APPENDIX 1

PLANNING APPLICATION BLE/19377 & BLE/19377/1-LB RESPONSE FROM BLEWBURY COUNCIL

PROPOSED ELEVATIONS

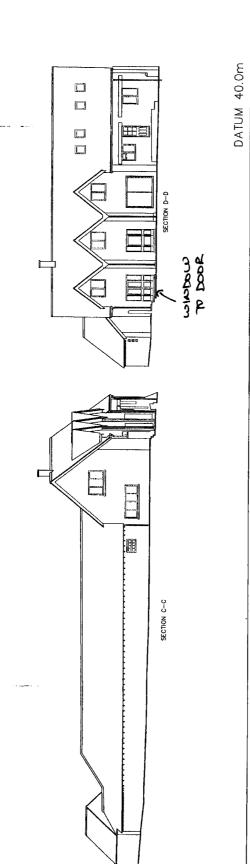
- 3. The porch design is out of keeping with what is currently a vernacular courtyard development. We are also concerned about the potential impact to the exterior wall that currently curves round from Westbrook Street to London Road as an unbroken whole. Should the conversion go ahead, permitted development rights would very likely result in this wall being broken up by windows, doors or gates, thereby adversely affecting the streetscape and visual amenity in a conservation area.
